Oregon Department of Aviation

SUBJECT: Oregon Department of Aviation (ODAV) Agency Comments on Floodway
Development Permit #851-21-000321-PLNG: Coulter

1. ODAV Report on Permit #851-21-000321-PLNG

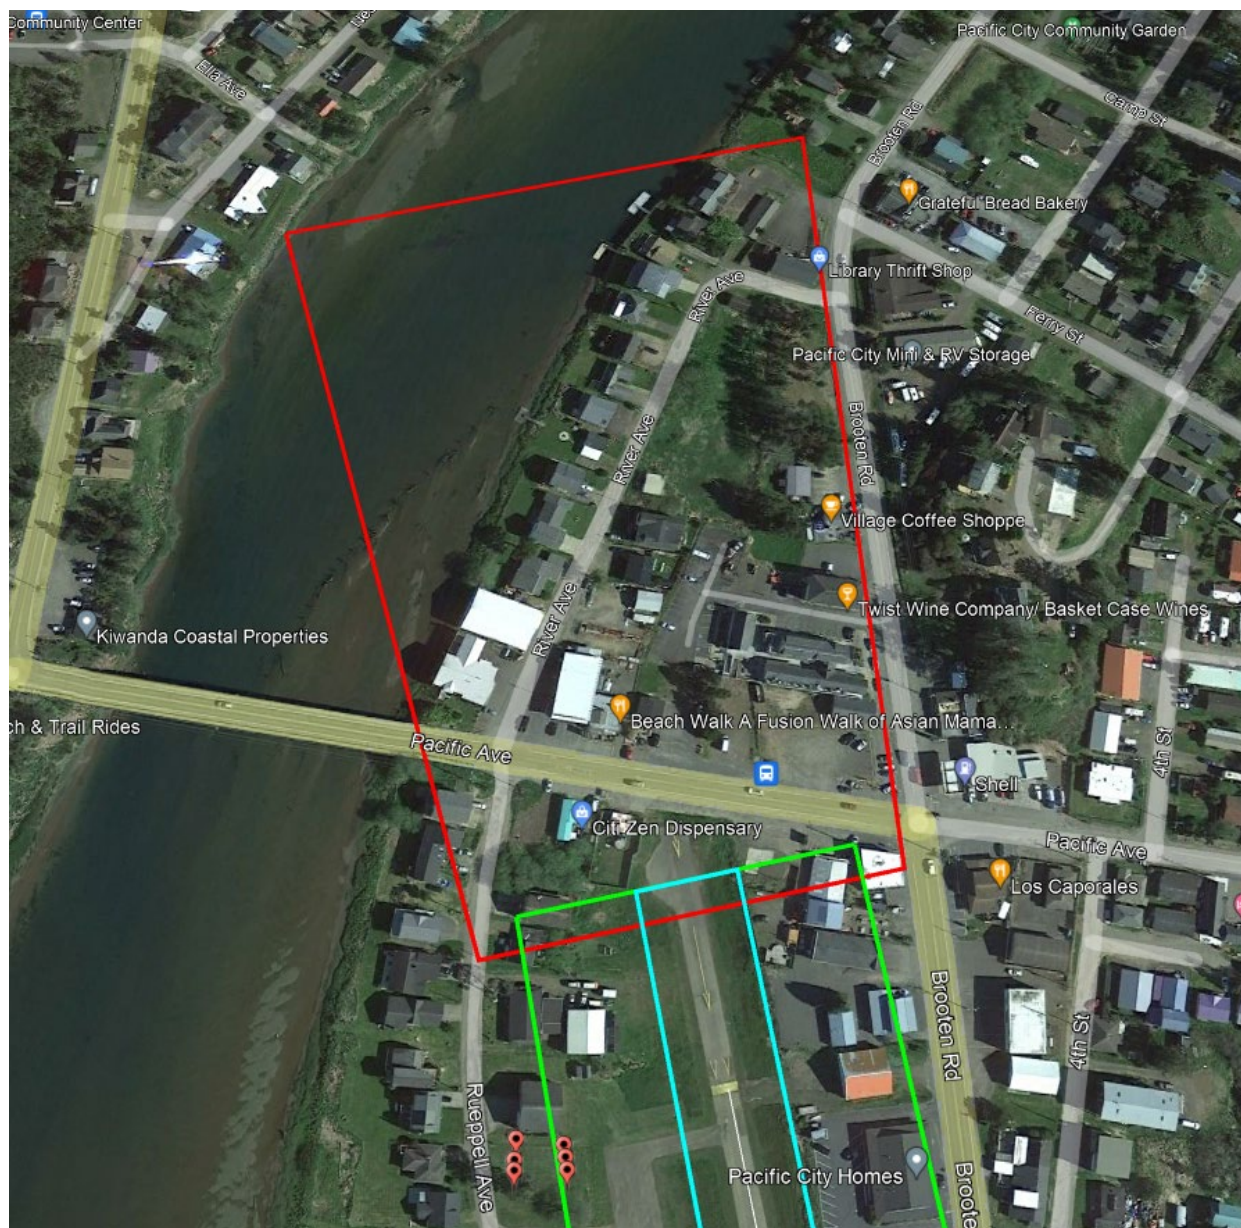
1. The proposal appears to be within the Runway Protection Zone (RPZ) of Runway 14 at the Pacific City State Airport (PFC). No structures shall be allowed within the RPZ per the Airport Land Use Compatibility Guidebook - Table 3-4: Compatible Land Uses per FAR Part 77 Surfaces and FAA Safety Areas and FAR Part 77 federal standards. Please see attached for reference. Exceptions shall be made only for structures accessory to airport operations whose location within the RPZ has been approved by the Federal Aviation Administration. The below screenshot represents the proposal's location in proximity to Runway 14 and the RPZ. Please note that the portion of land outlined in red represents the RPZ.

2. In accordance with FAR Part 77.9 and OAR 738-070-0060, all new proposed structures within this proposal are required to undergo aeronautical evaluations by the FAA and ODAV prior to construction. The aeronautical evaluations are initiated by the applicant providing notice to the FAA and ODAV to determine if the proposed construction poses an obstruction to aviation safety at Pacific City State Airport. The applicant must receive the resulting aeronautical determination letters from the FAA and ODAV prior to approval of any building permits.

3. The height of new structures shall not penetrate FAR Part 77 Imaginary Surfaces, as determined by the FAA and ODAV.
4. Exterior lighting shall be designed as to not interfere with aircraft or airport operations.

5. Trees and other planted vegetation shall not penetrate FAR Part 77 Imaginary Surfaces.
